Serial: RNP-RA/02-0180

H. B. ROBINSON STEAM ELECTRIC PLANT, UNIT NO. 2
DOCKET NO. 50-261 / LICENSE NO. DPR-23

**RESPONSE TO REQUEST FOR ADDITIONAL INFORMATION
REGARDING SEVERE ACCIDENT MITIGATION ALTERNATIVES ANALYSIS**

RESPONSE TO REQUEST FOR ADDITIONAL INFORMATION REGARDING SEVERE ACCIDENT MITIGATION ALTERNATIVES

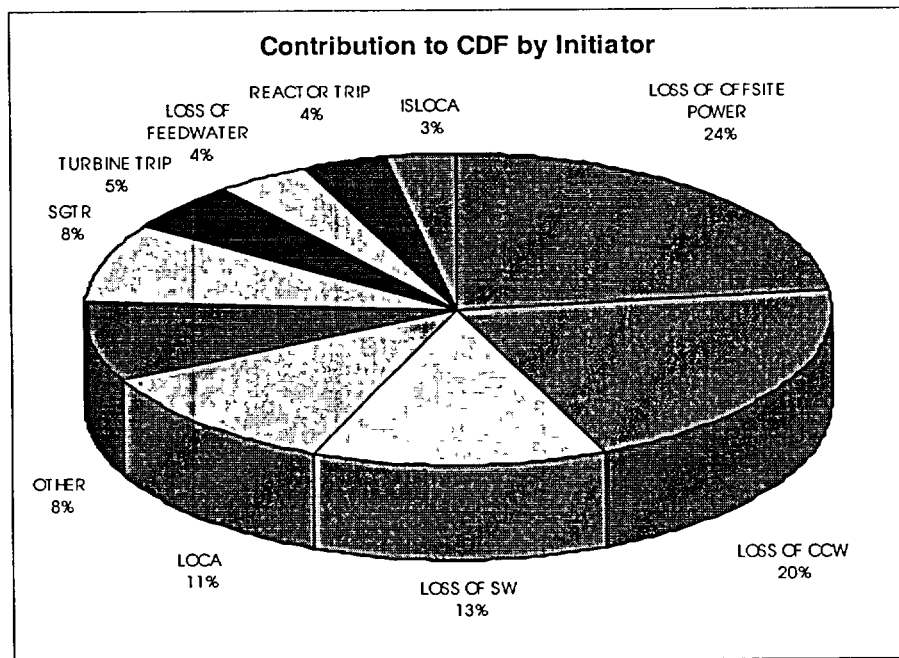
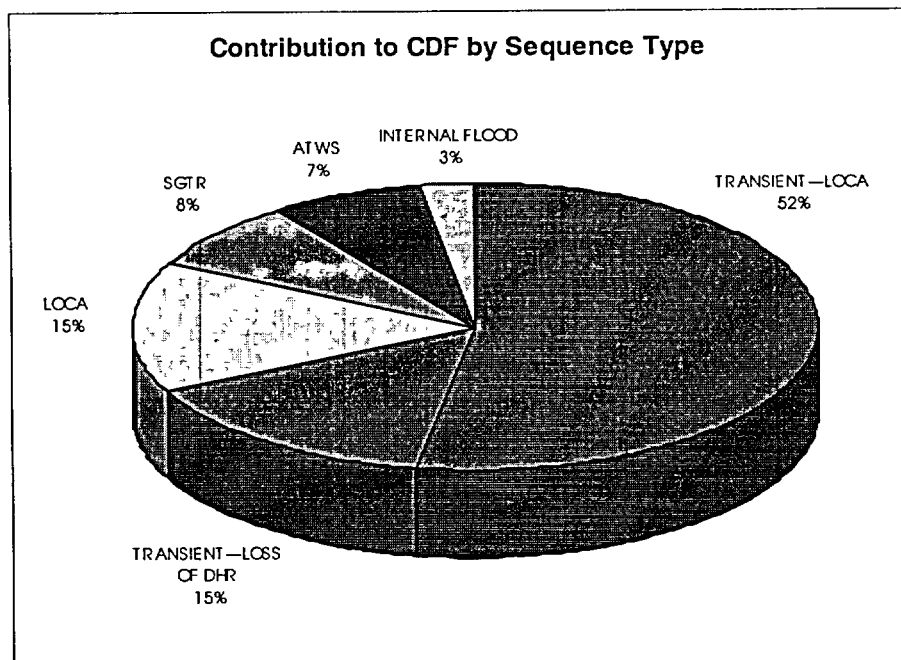
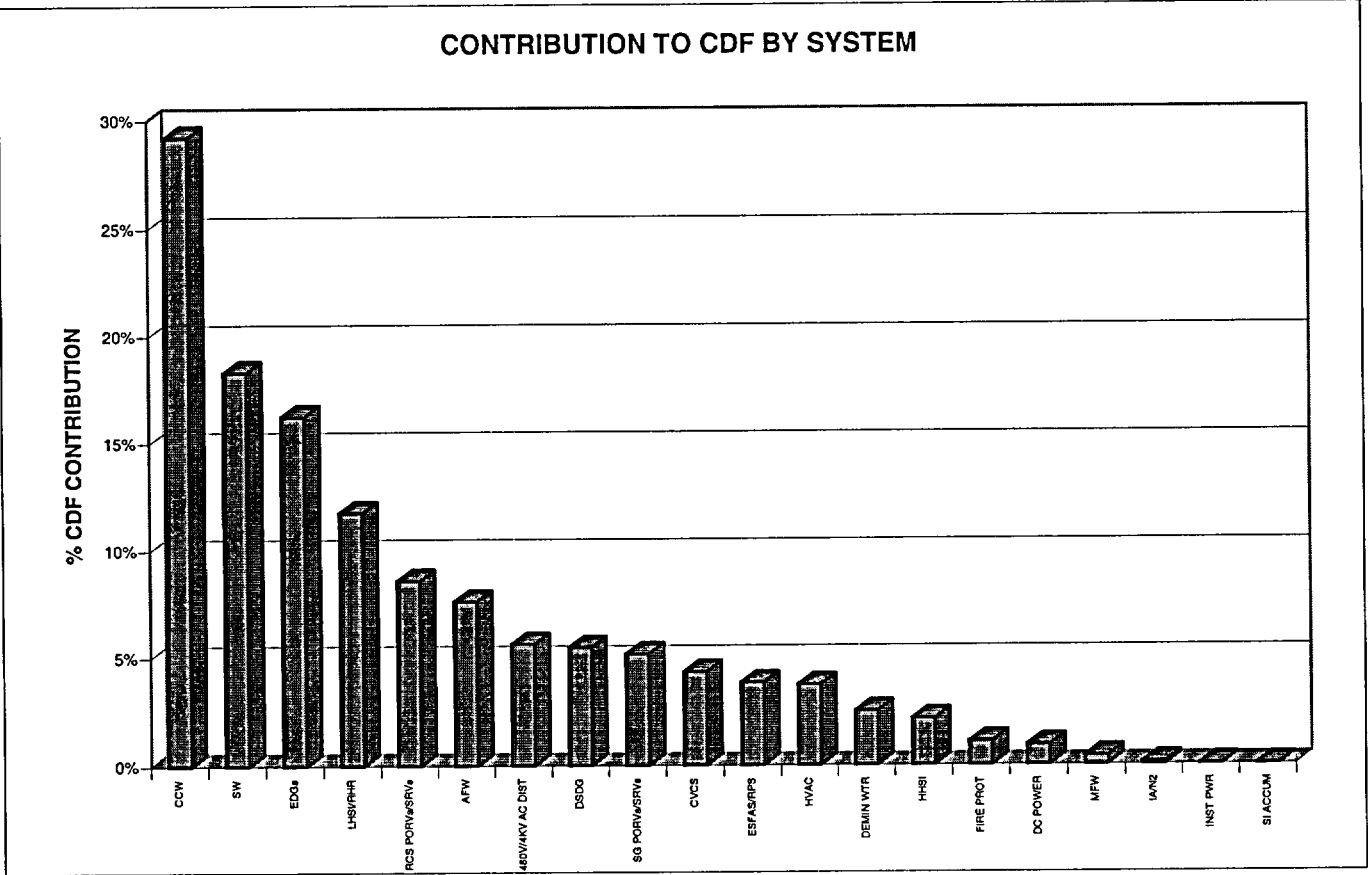
“a breakdown of the internal event CDF and LERF by major contributors, in a format similar to that used in either the IPE or the 1997 PSA summary report,”

The follow figures are updated versions of the figures in the 1997 PSA Summary Document.
